**RESOLUTION No. 12/13-35
CITY OF DAYTON, OREGON**

Title: A Resolution Adopting Public Works Design Standards Update No. 5

SUBJECT: Public Works Design Standards Update No. 5

LAST REVISION DATE: FEB 2013	
SIGN POST WITH TELESPAR BASE & ANCHOR (REQUIRED IN ODOT R.O.W) (NTS)	
DAYTON, OR	DETAIL NO. 232

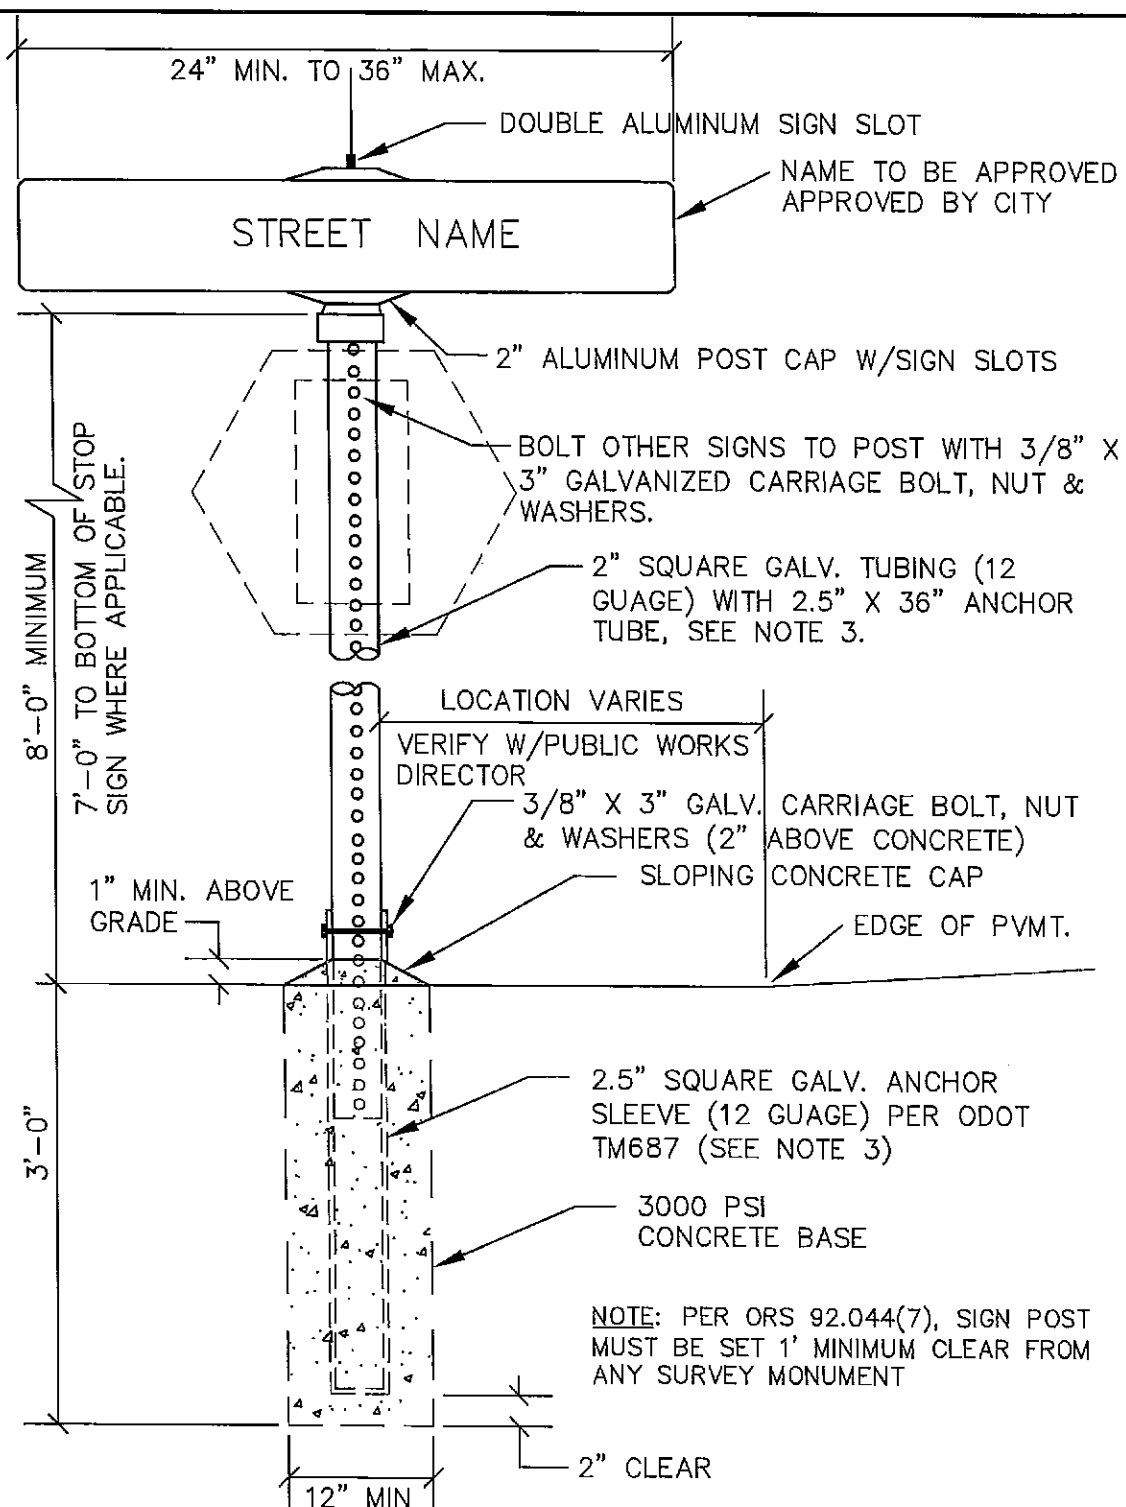
48. Detail 232: A new detail was added to address street sign post requirements in the ODOT right-of-ways. The new detail (see attached) is dated 2/13.

LAST REVISION DATE: JUNE 2012	
AC STREET CUT SURFACE RESTORATION W/BENCH GRIND (NTS)	
DAYTON, OR	DETAIL NO. 302A

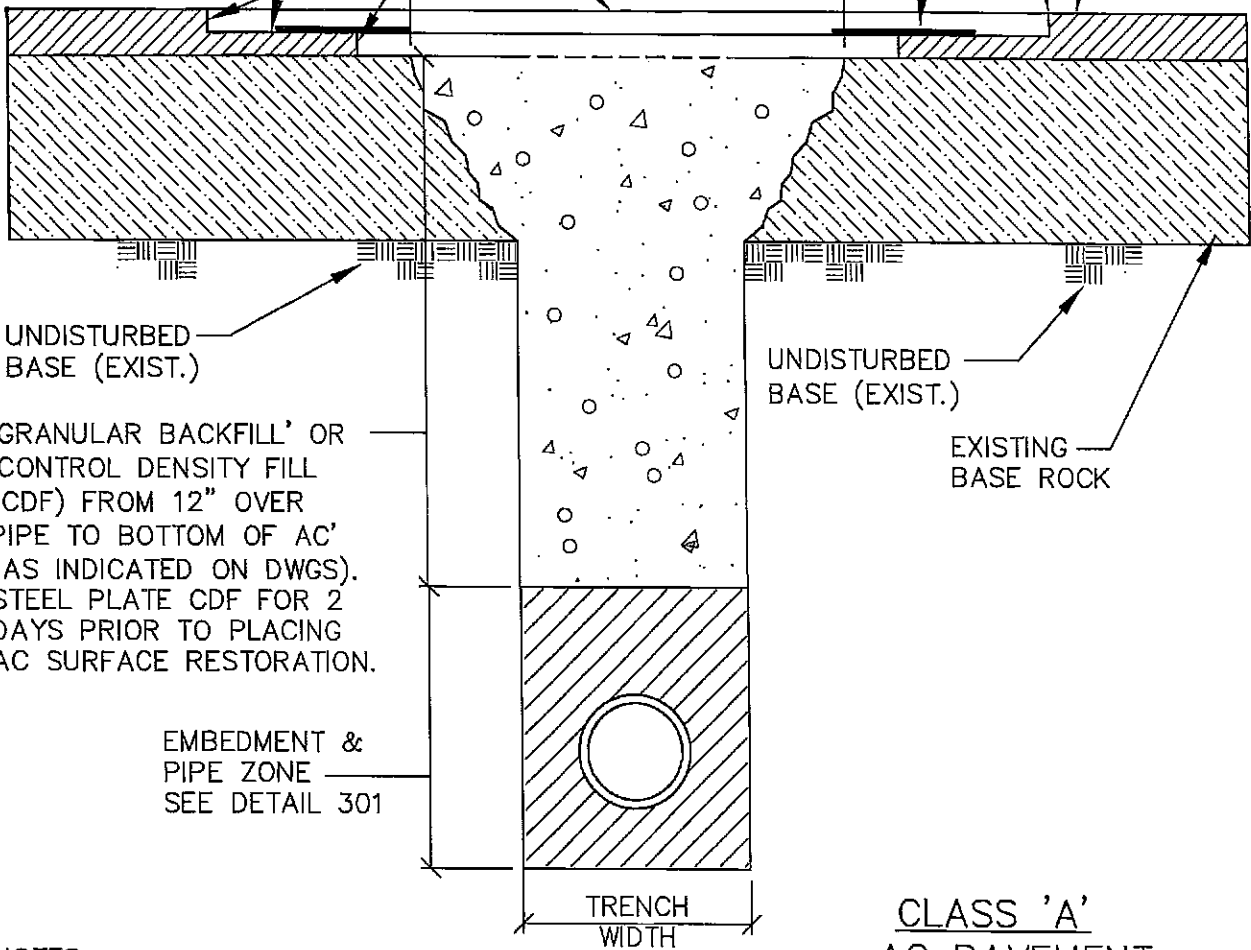
49. Detail 239: A new detail was added for a standard pre-cast concrete wheelstop. The new detail (see attached) is dated 1/13.
50. Detail 302A & 302B: The bench grind detail was modified to reference pre-tacked paving fabric (18" width rather than 36" width) now specified for use. The revised details (see attached) are dated 6/12.

LAST REVISION DATE: JAN 2013	COPYRIGHT 1986 WESTECH ENGINEERING, INC.
STANDARD SIDE-INLET GRATED CATCH BASIN	
(NTS)	
DAYTON, OR	DETAIL NO. 310

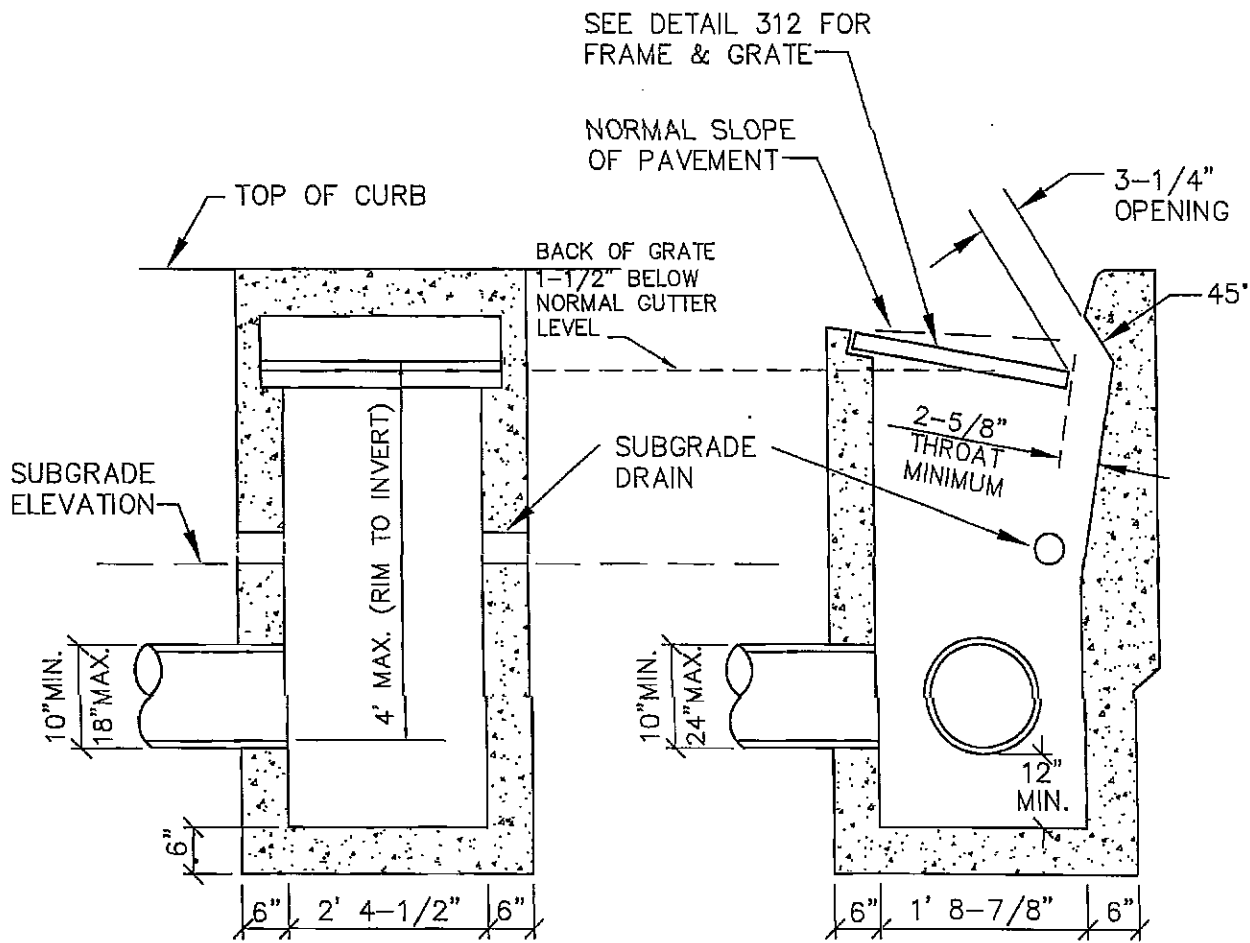
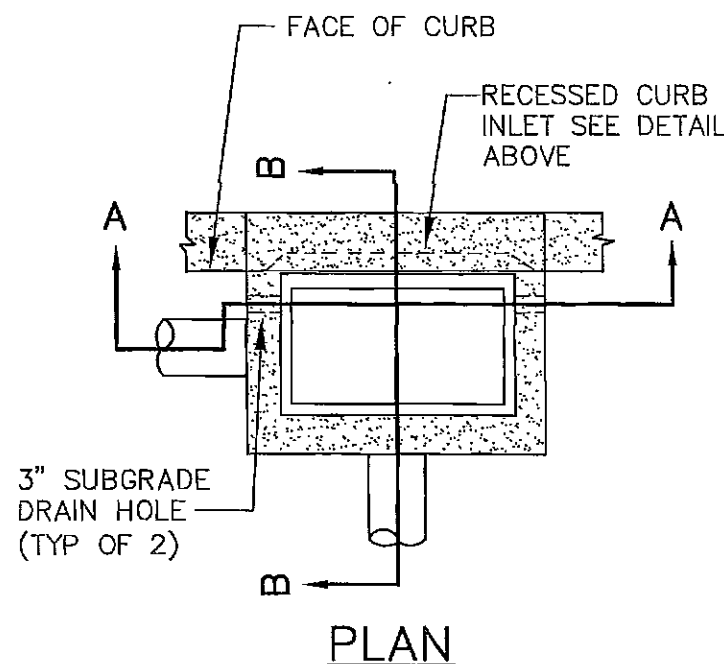
51. Detail 310 & 311: The detail notes were modified to clarify that the curb-inlet notch is to be eliminated at drop curb locations where approved by the City. The revised details (see attached) are dated 1/13.

LAST REVISION DATE: JAN 2013	JO #
PARKING LOT CATCH BASIN (TRAFFIC RATED PVC w/TRAP, DUCTILE IRON FRAME/GRATE)	
(NTS)	
DAYTON, OR	DETAIL NO. 317

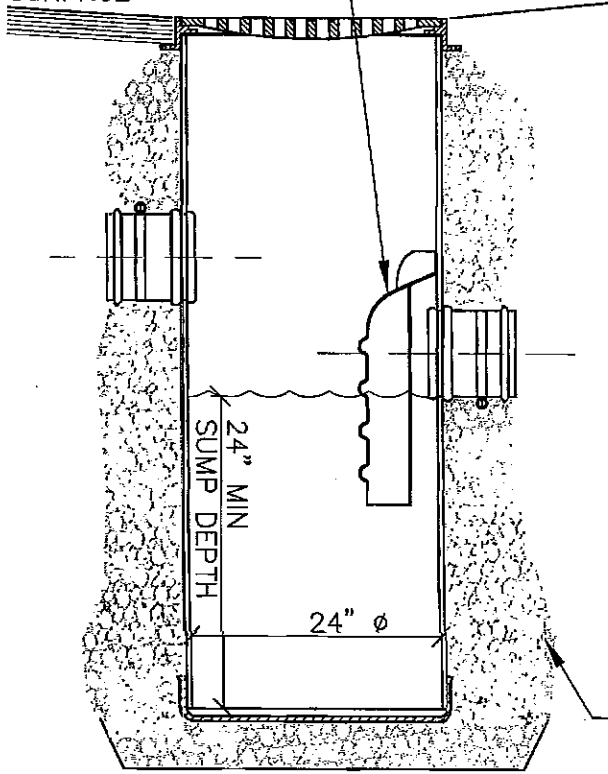
53. Detail 317: A new style of parking lot catch basin has been approved by the State Building Codes division for use where trapped catch basins are required. The new detail (see attached) is dated 1/13.

LAST REVISION DATE:	MAR 2010
POLLUTION/FLOW CONTROL MANHOLE W/OVERFLOW	
(NTS)	
DAYTON, OR	DETAIL NO. 320

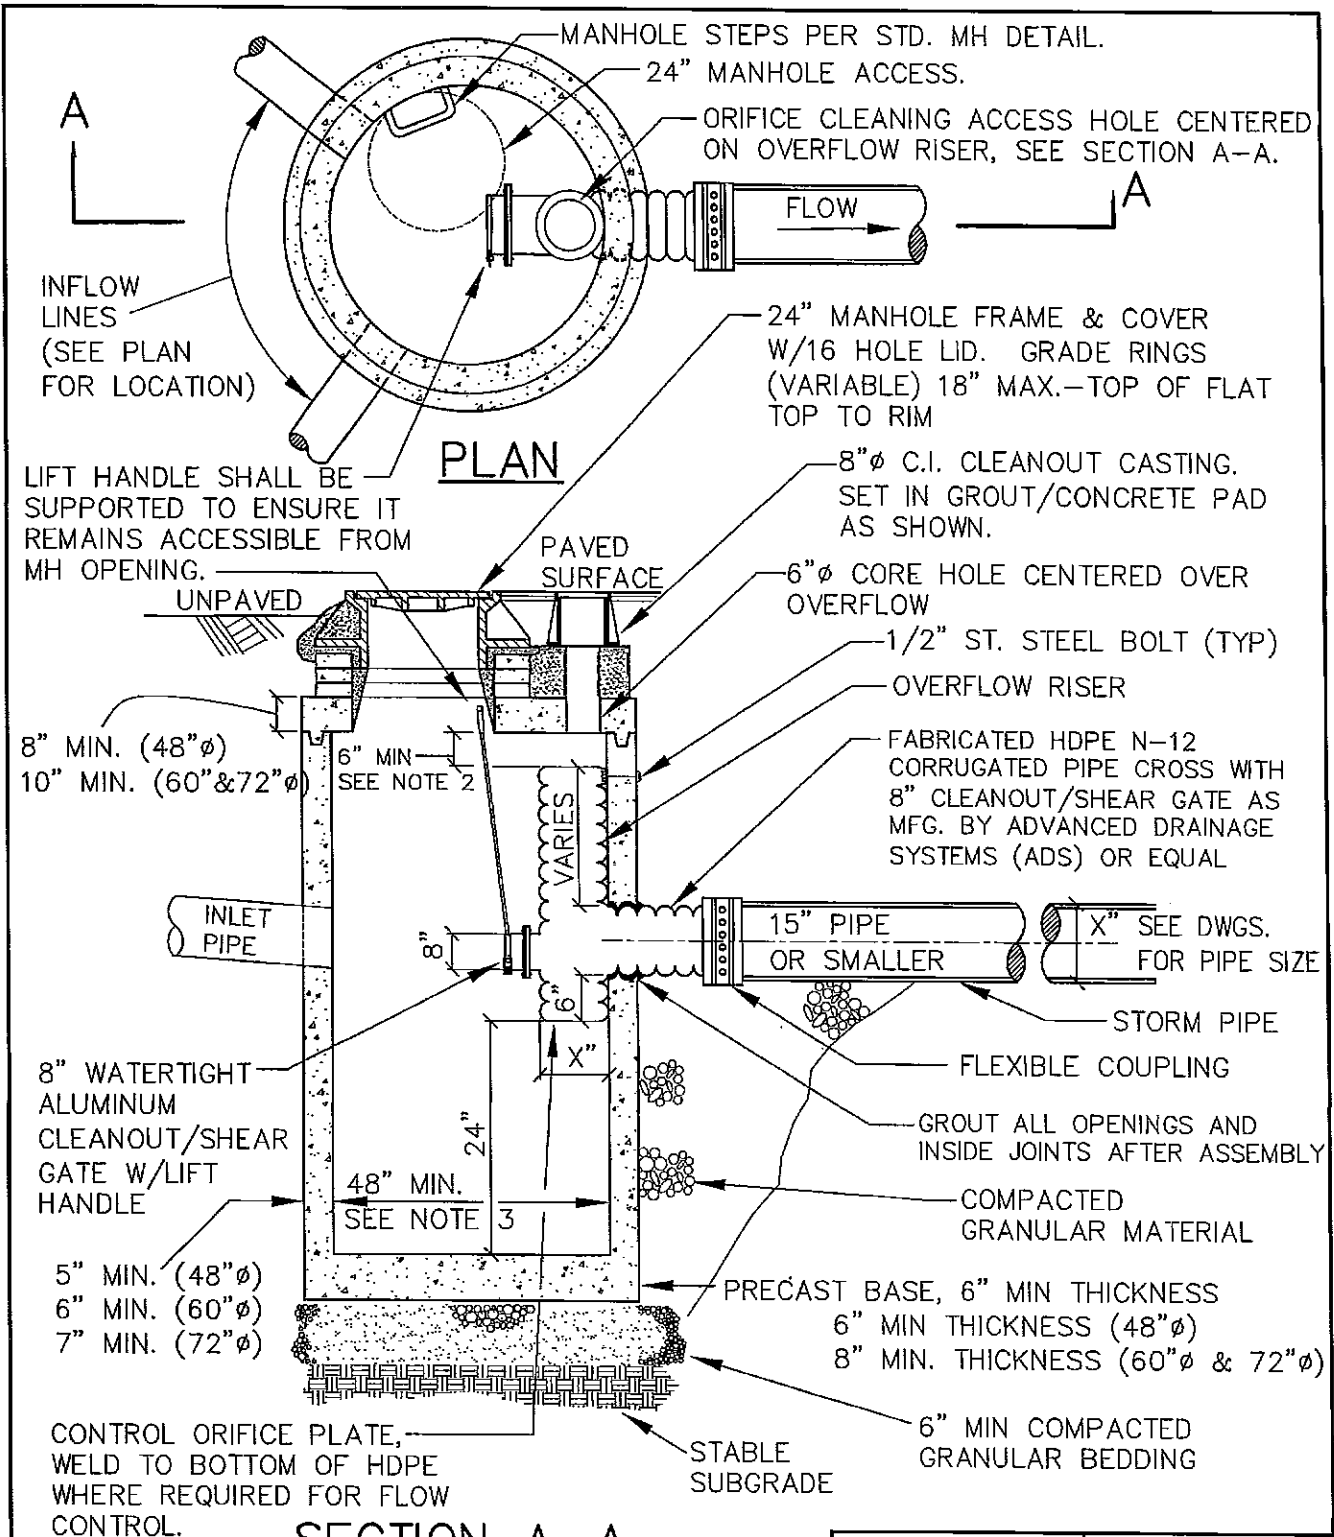
54. Detail 320: The flow control manhole detail was modified to eliminate the expense of using a 30" manhole frame & casting with custom drilled holes, and allows instead standard manhole frame & cover with a cleanout casting for access over the overflow riser. The revised detail (see attached) is dated 3/10.

LAST REVISION DATE: AUG 2012	JO #
24" DIA. STORM MANHOLE (TRAFFIC RATED PVC W/SOLID DUCTILE IRON FRAME/COVER) (NTS)	
DAYTON, OR	DETAIL NO. 351

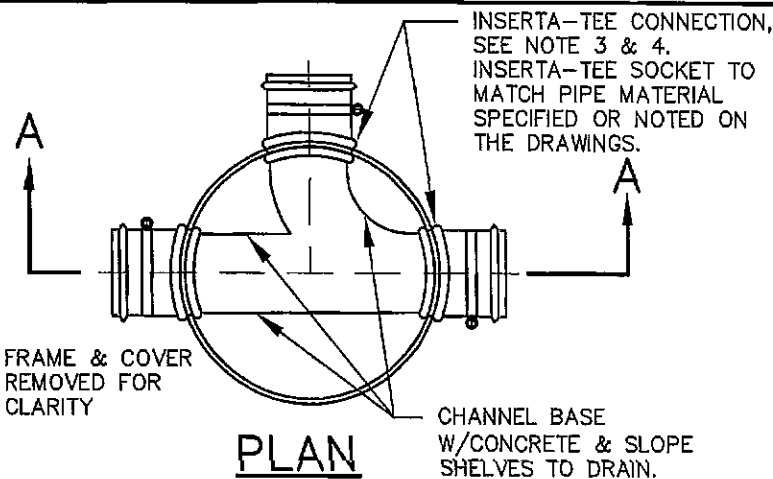
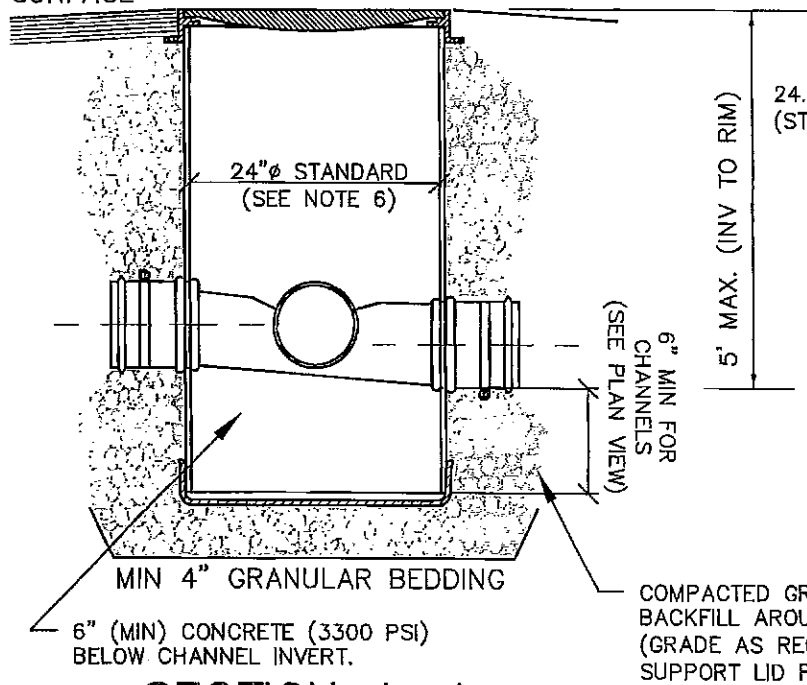
55. Detail 351: A new style of 24" diameter storm manhole has been approved for use in parking lots or within City right-of-ways. The new detail (see attached) is dated 8/12.

LAST REVISION DATE: APR 2013	COPYRIGHT 1999 WESTECH ENGINEERING, INC.
STANDARD MANHOLE FOR 21" PIPE AND SMALLER	
(NTS)	
DAYTON, OR	DETAIL NO. 401

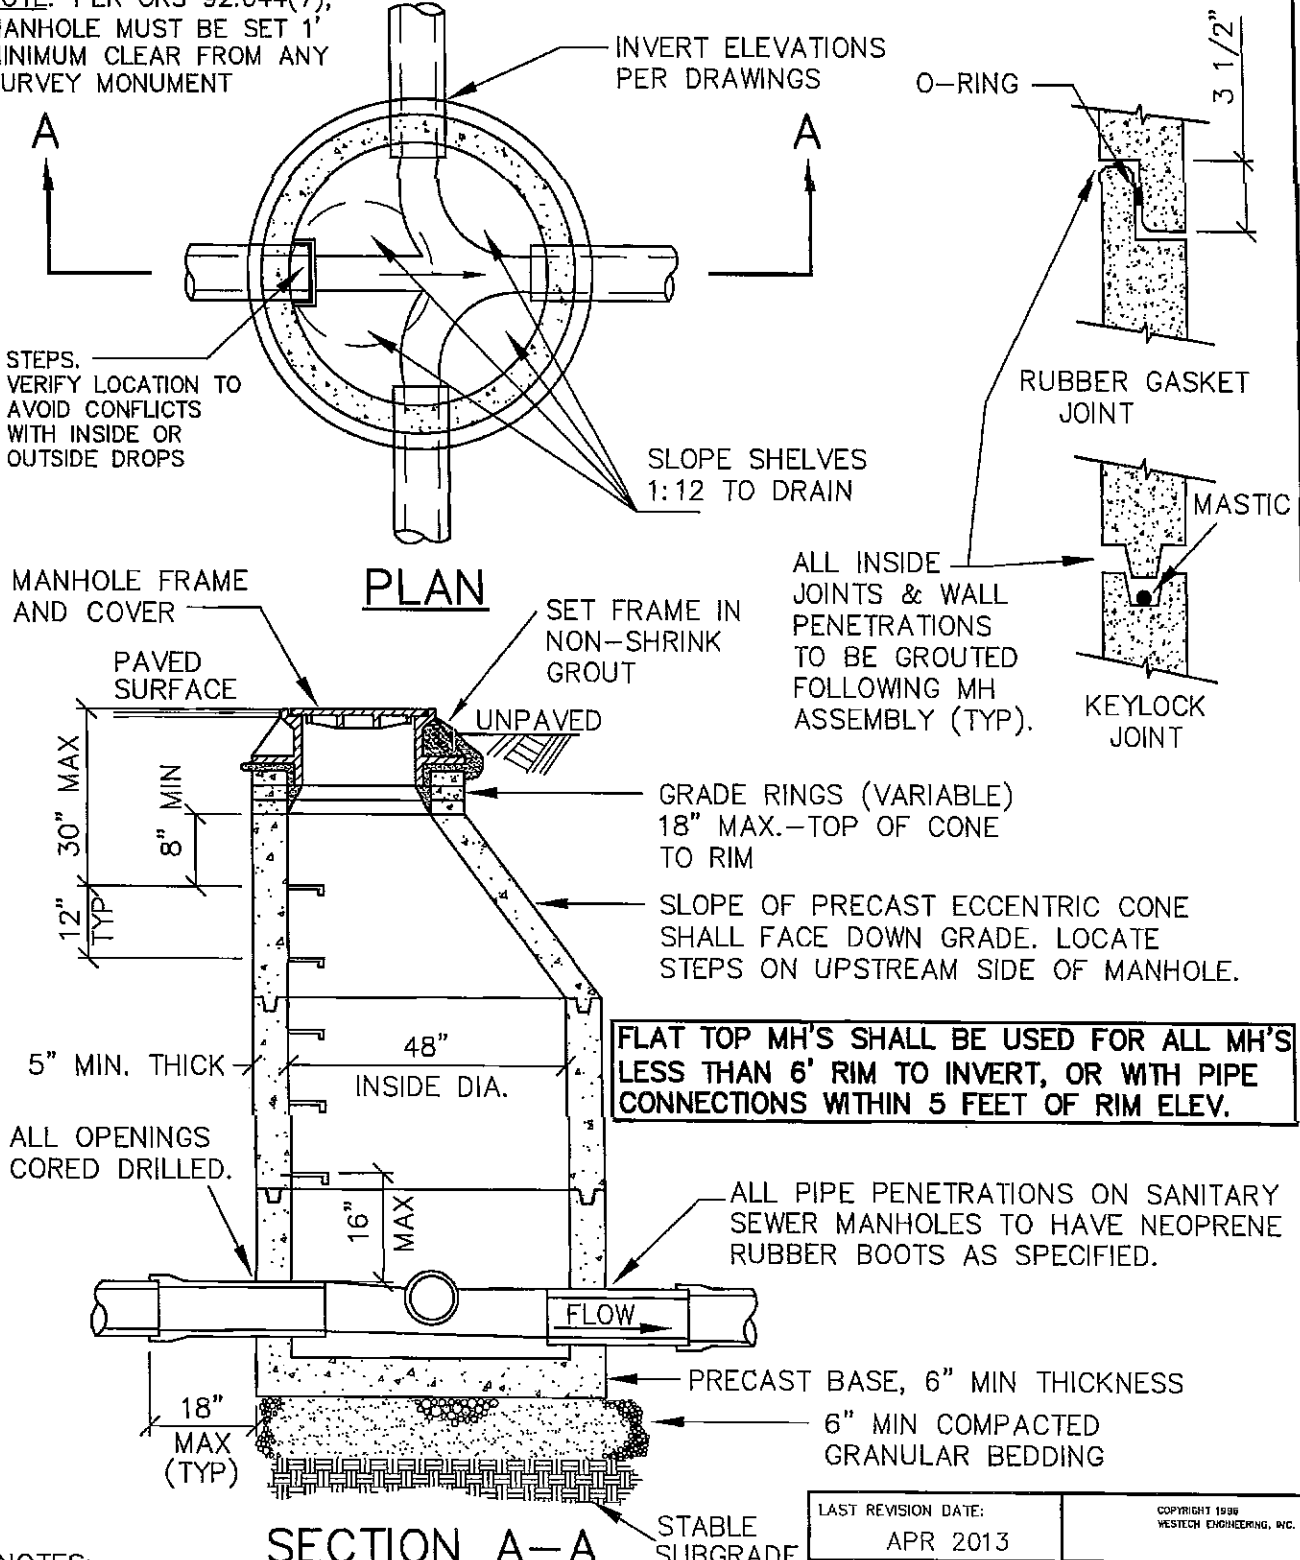
56. Detail 401: The detail notes were modified to clarify that in addition to flat-top manholes being required for manholes less than 6 feet rim to invert, flat-top manholes are also required where there are pipe connections are within 5 feet of the rim elevation. The revised detail (see attached) is dated 4/13.
